Crystal River Nuclear Plant
Docket No. 50-302
Operating License No. DPR-72

October 9, 2009
3F1009-03

Subject: Crystal River Unit 3 – Response to Request for Additional Information Regarding Severe Accident Mitigation Alternatives for Crystal River Unit 3 Nuclear Generating Plant License Renewal Application (TAC NO. ME0278)

Figure 8. CR3 Containment Event Tree (page 1 of 4)

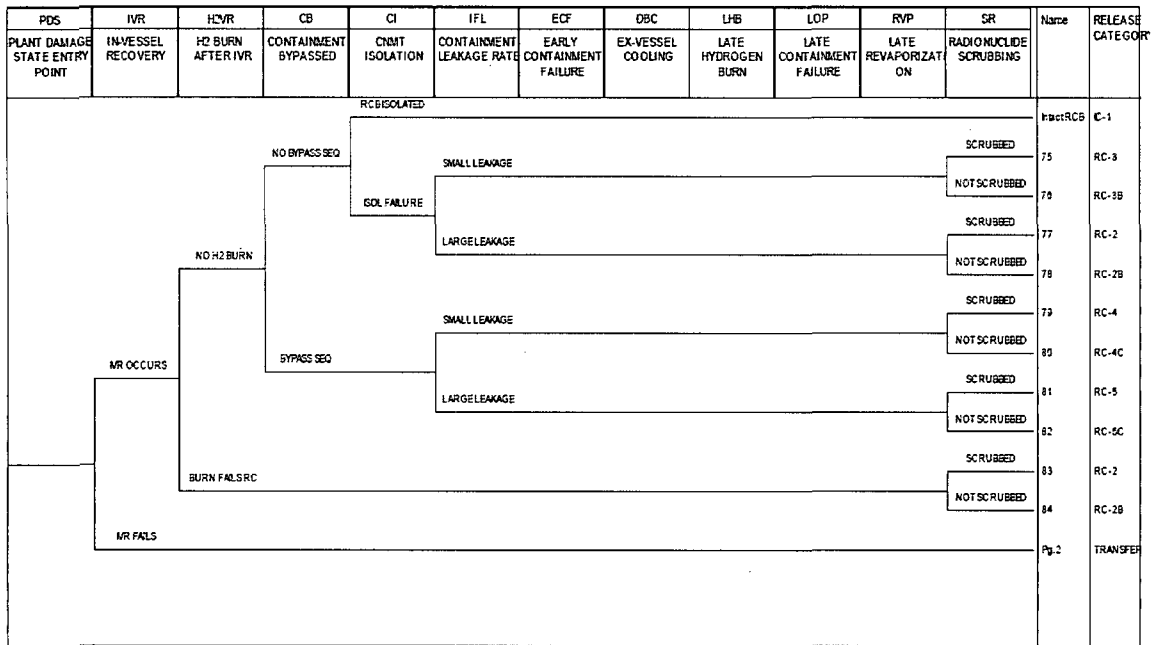
- ii. Provide a description of the process used to group the containment event tree (CET) end states into release categories. Provide a typical CET showing release categories assigned to each end state.

The main characteristics of the containment end states considered when developing these release categories were:

- Release Energy
- Containment Isolation Failure Size
- Timing of The Release
- Isotopic Composition

FIGURE 1
SAMA 8 CONCEPTUAL DESIGN

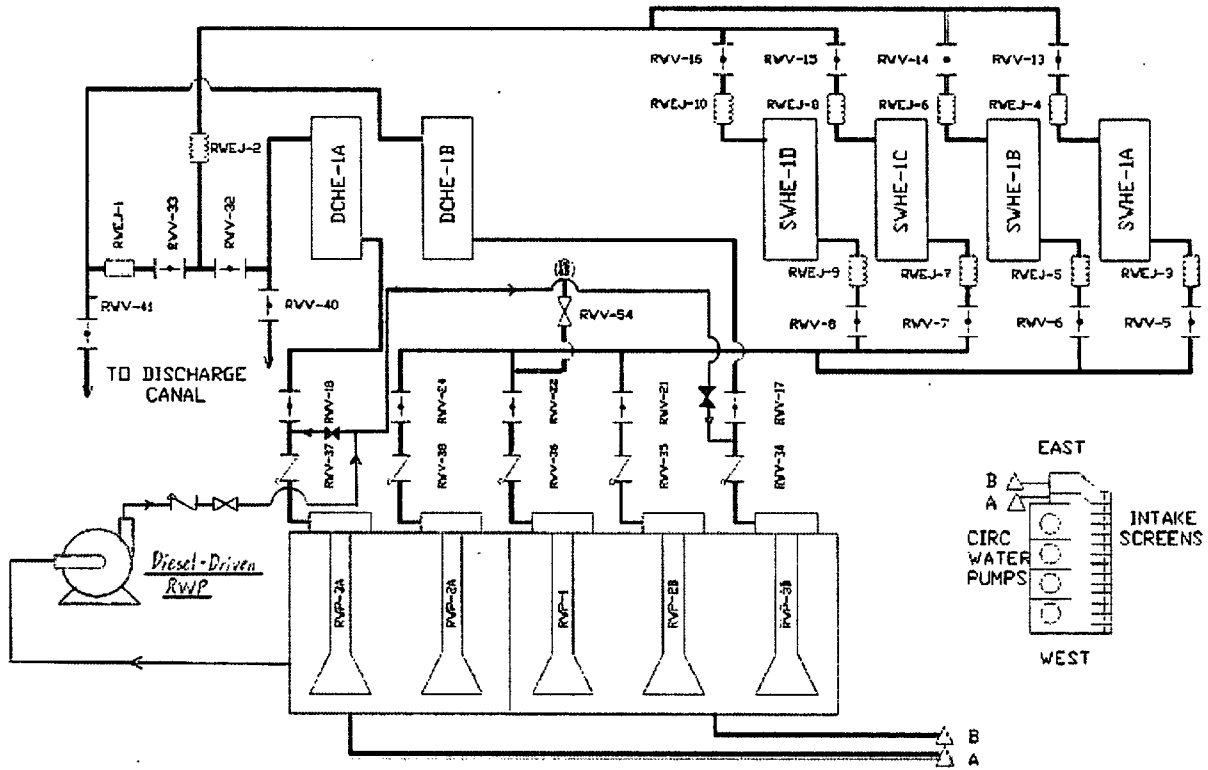
SAMA 8: Provide a Temporary Pump to Provide a Backup Supply of Cooling Water in Lieu of Raw Water Pump

The purpose of this particular SAMA is to provide a backup raw water pump capable of supplying sea water to either of the DH system coolers (DCHE-1A(B)). Since the pump is assumed to be of a different design, it was assumed that the motive power for this alternate pump would be supplied by an air-cooled diesel engine, so as not to rely on any of the support dependencies normally used by the RW-DC pumps RWP-3A(B). The suction source for this pump would come from the same common suction pit as is used by the normal standby pumps. A crosstie just upstream of the RWP-3A(B) pump discharge valves would need to be installed with normally closed manual valves between the two trains, such that this alternate diesel-driven pump could supply either, but not both, of the two DHCCC trains (see Figure 1). A connection to this crosstie from the discharge of the proposed backup RW-DC pump would need to also be installed, the discharge of which would also consist of a manual discharge valve (normally open) and a check valve to prevent backflow from any of the already installed RW-DC pumps should they be in a running condition.

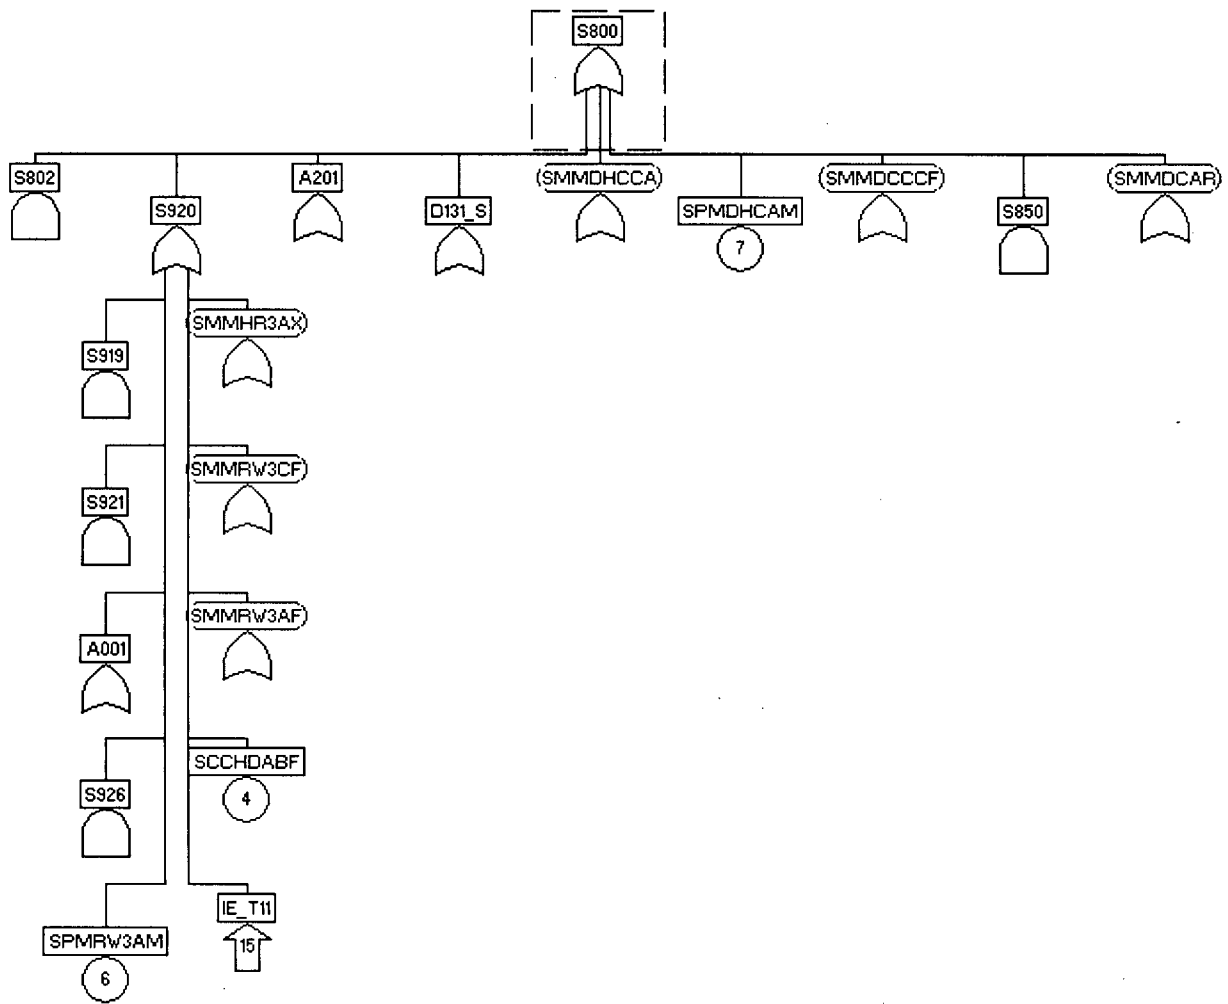
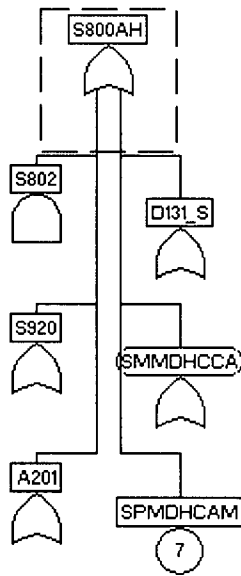
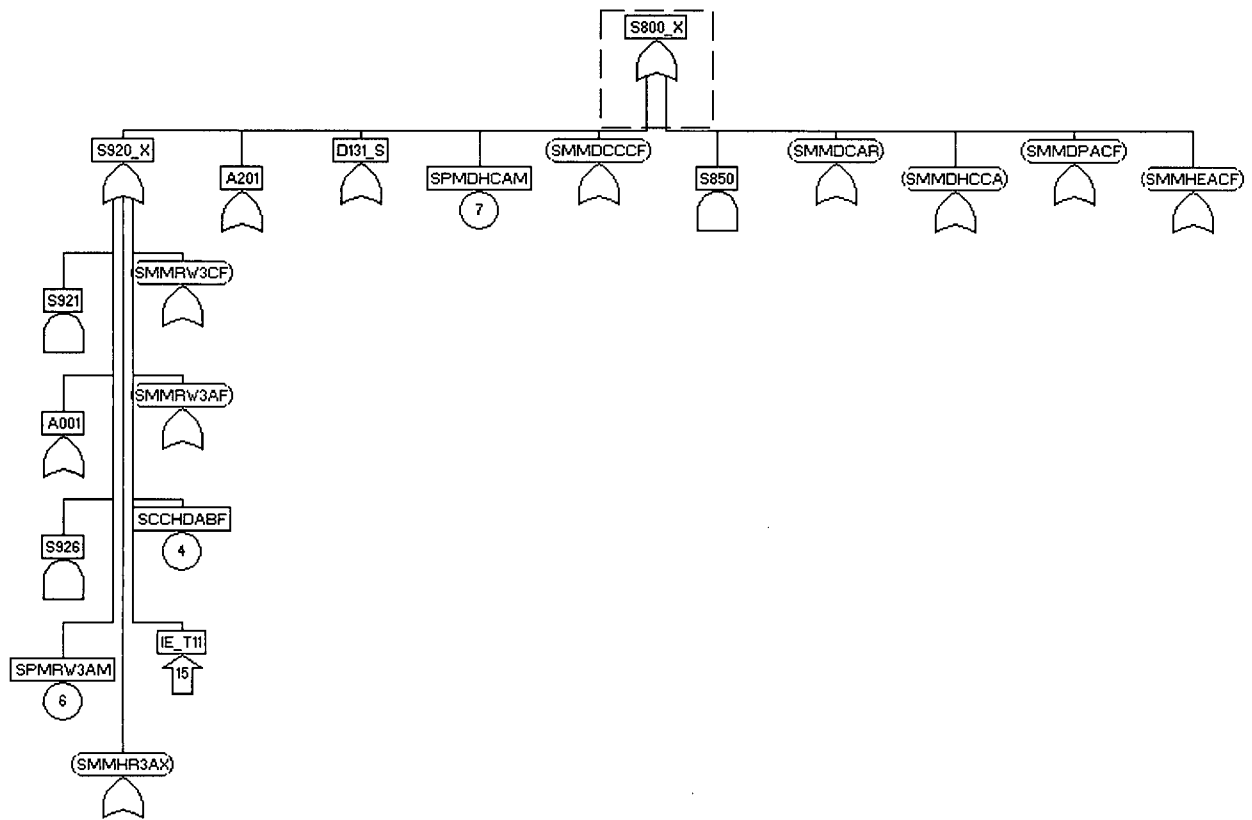
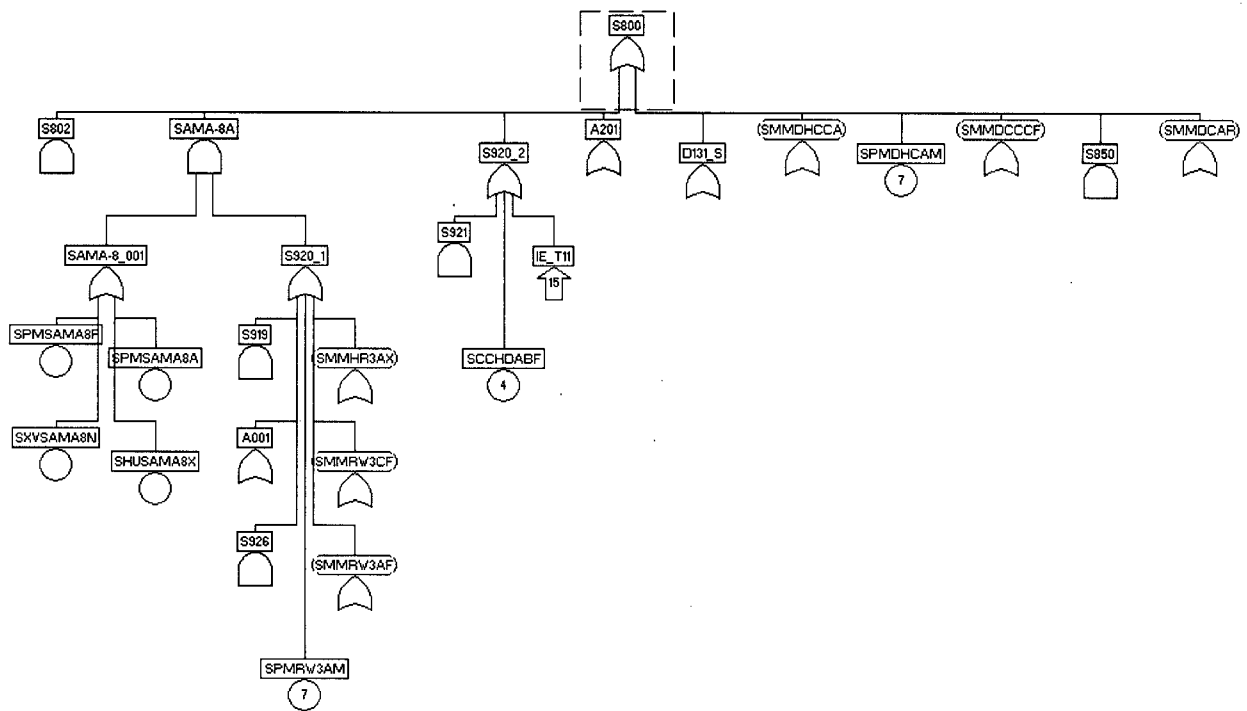
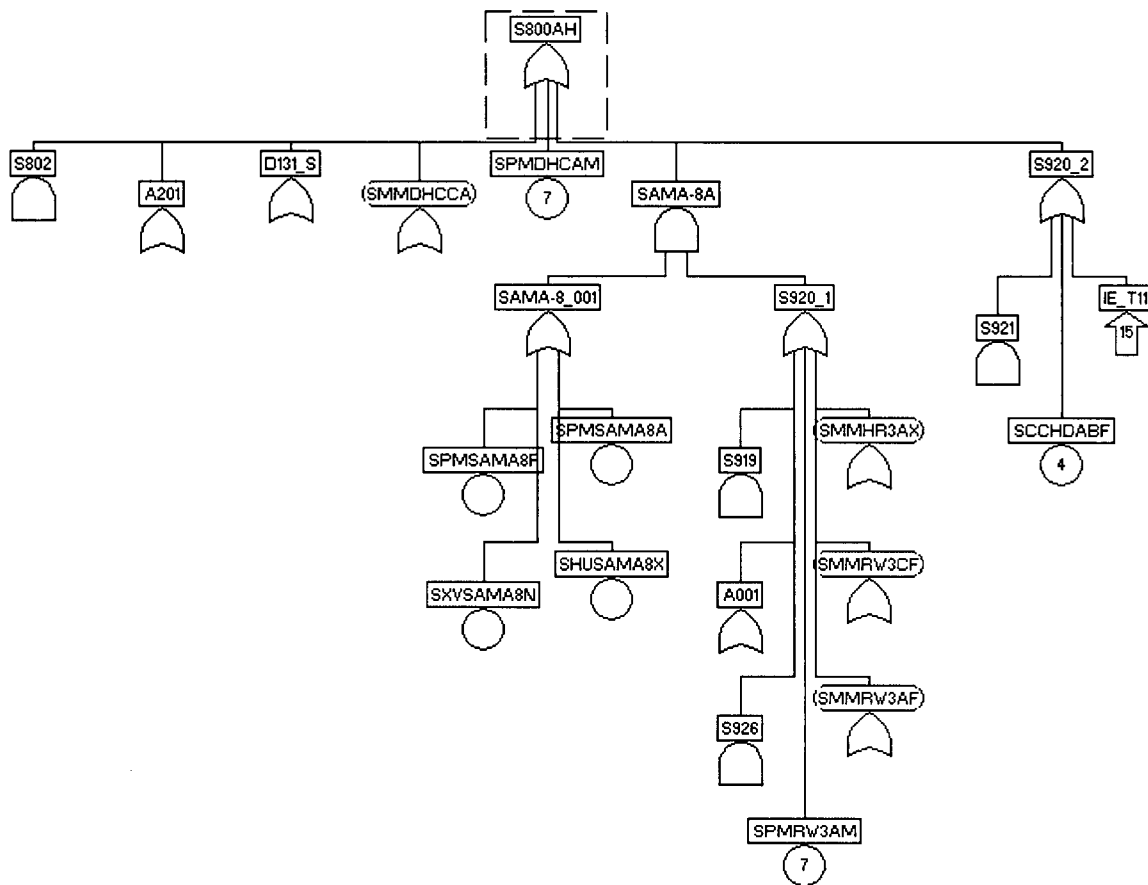
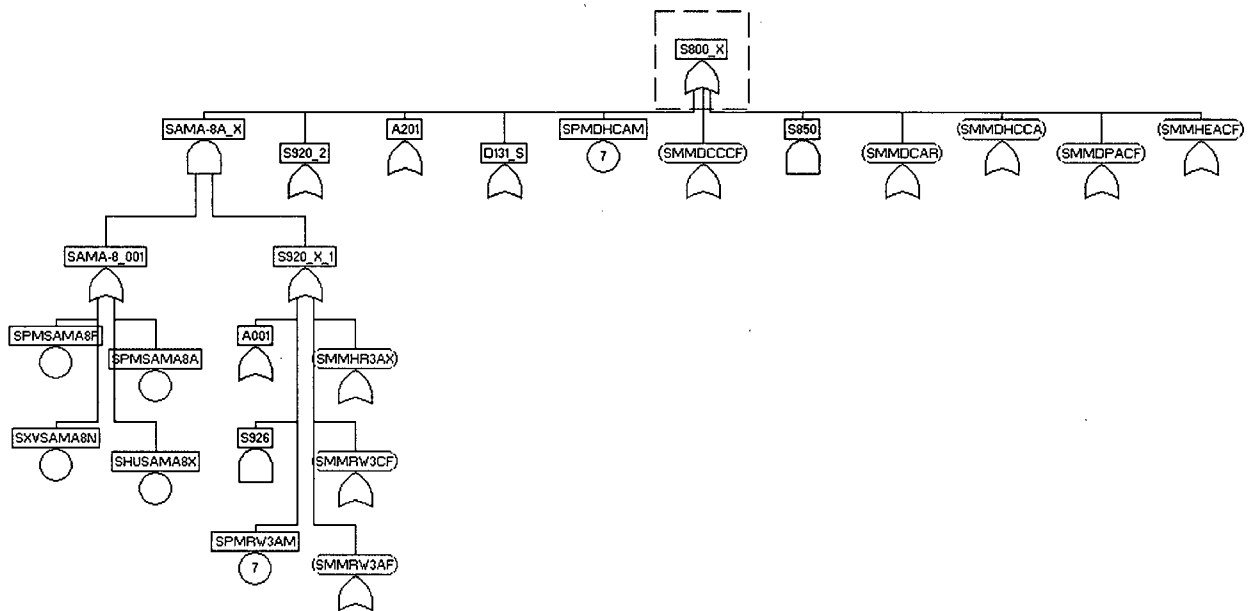
To calculate the consequences of implementation of this SAMA, the logic beneath gates S800 and S800AH was modified to account for this proposed backup RW-DC system. Also, to separate the decay heat cooler faults from the RWP failures that were under OR gate S920, two new gates were created, i.e., S920_1 for non-DCH faults and S920_2 for DCH faults. That is, a backup RW pump would not be able to mitigate any failures associated with heat exchanger faults associated with components DCHE-1A and DCHE-1B. Similarly, the logic structure under OR gate S800_X for recirculation mode was also modified to allow recovery of RW-DC using this backup RW pump.

To better illustrate the logic changes made, Figures 2a through 2c represent that portion of the original logic of the CR-3 PRA model that was considered applicable to this SAMA, and Figures 3a through 3c represent the additional and modified logic that was used to simulate implementation of this SAMA.

Implementation of this SAMA yielded a moderate reduction in CDF, but only a relatively small change in the Dose-Risk, and Offsite Economic Cost-Risk (OECR). The results are summarized in the following table for CR-3:

CDF	Dose-Risk	OECR
Base Value	4.95E-06	3.79	\$6,624
SAMA Value	3.86E-06	3.75	\$6,582
Percent Change	22.1%	1.1%	0.6%
